Wiltshire Council Planning Consultation Response

URBAN DESIGN

Application No: PL/2026/00135

Proposal: Approval of reserved matters for the demolition of existing structures and construction of 90 homes, with areas of open space, a play area, sustainable drainage infrastructure, internal roads, paths and parking areas, landscaping and associated works, plant and infrastructure and discharge of conditions 7 (boundary with Abberd Farm), 8 (Surface Water), 9 (Surface Water), 14 (Construction Ecological Management Plan), 15 (Landscape Ecological Management Plan), 16 (Lighting), 17 (Wildlife Features) and 18 (Noise Assessment) of outline planning permission PL/2022/07893

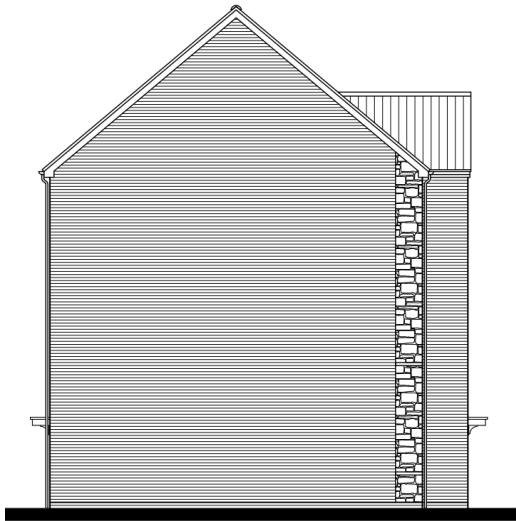
- **Plot 38 siting:**

The EPP shows buildings along this edge set back from H2, H7 and H9. Plot 38 is now positioned closer to H10 and encroaches into the buffer shown on the EPP. As a minimum, Plot 38 should be set back 4.0 m from H10, consistent with the dark corridor requirement for H11.

Recommendation: These matters were raised at Pre-application but have not yet been addressed. The applicant should demonstrate how the layout will maintain the buffer offsets required to comply with the approved Ecology Parameters Plan.

Plot 18 Oakham (stair well window only)

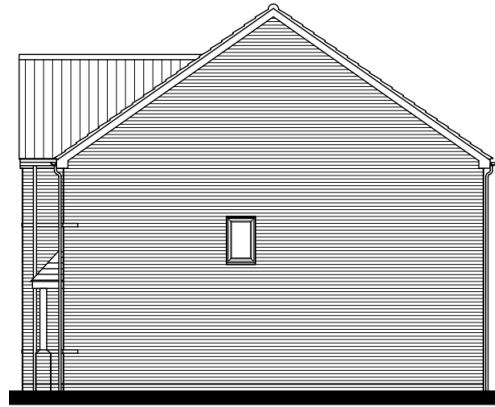
- 7) Street/street corner return elevations and street/open space corner return elevations have largely attractively placed and proportioned windows utilising house types that are consciously designed for this purpose, but there are the following exceptions below in locations. These would represent 'what red looks like' BfHL (pp 54-55) rather than the preferred 'what green looks like' (pp 52-53), and WDG expectation 4.2.8. *'Where buildings are on a corner both public elevations should be designed as 'frontages' and have windows from habitable rooms in them'.*

Plot 62 Cranford (wc window only)

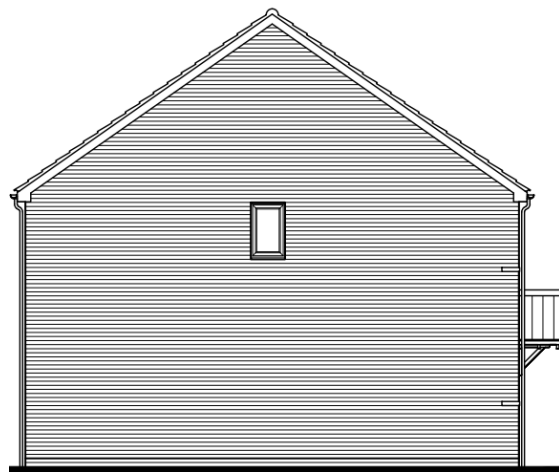
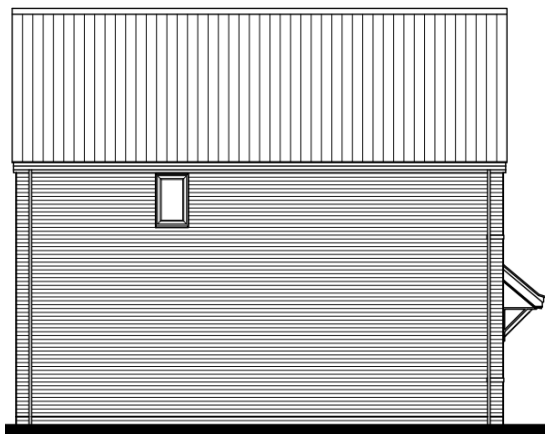
Plot 63 etc. Gosford (landing window only) Plot 76 Fulford (wc window only)
